INFO-TECH CITROËN Racing C3R5 19-08**Sujet : Faisceau volant (904601998B)**

Subject : Steering wheel loom (904601998B)

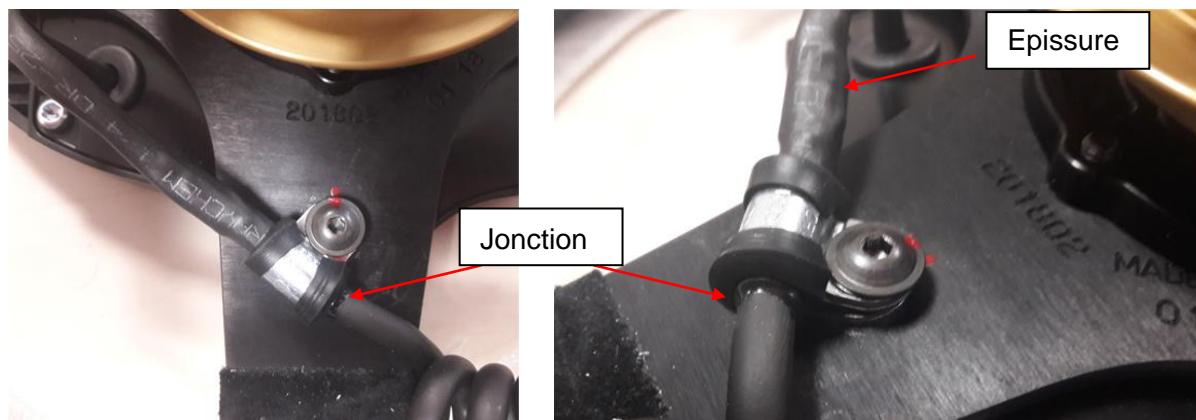
Afin de fiabiliser le fonctionnement de la platine volant (pour éviter des coupures de fils), merci de contrôler les points suivants :

- le faisceau est tenu par la jonction entre les 2 parties du faisceau et non sur ou juste à raz de l'épissure (repérable grâce à la surépaisseur du faisceau) pour éviter de cisailler le faisceau à cet endroit,
- veillez également à ce qu'il ne vienne pas entre le volant et le quick en orientant l'agrafe comme sur la photo,
- la protection de l'agrafe doit être correctement placée pour éviter de blesser le faisceau lors du serrage de l'agrafe,

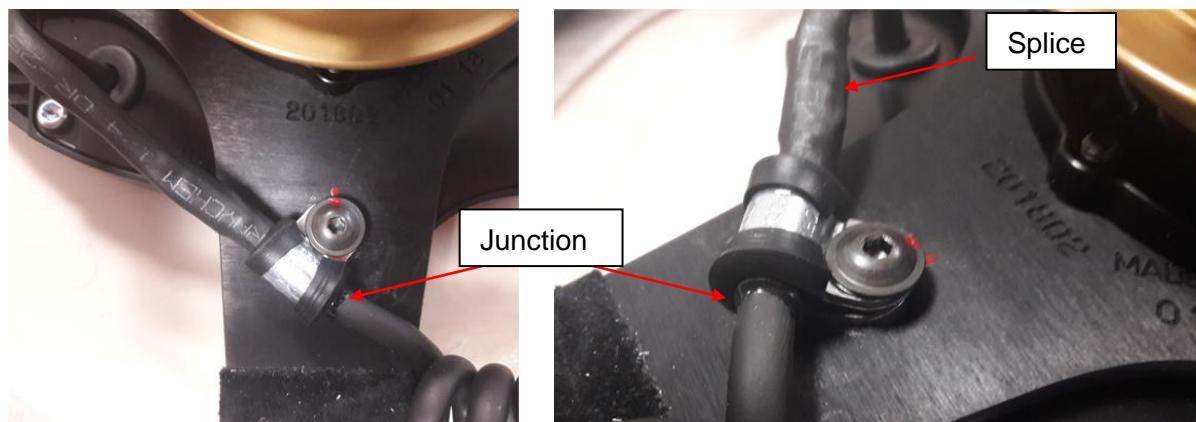
In order to improve the reliability of steering wheel panel (to avoid wire cut), please check the following points:

- the steering wheel panel loom is held by the junction of the 2 parts of the loom and not by the splice or just close to the splice (can be seen by the thicker part of the loom) to avoid to shear the loom,
- the loom does not interfere with the quick release by directing the staple clip as on the picture below,
- the staple protection is well placed to not damage the loom during tightening,
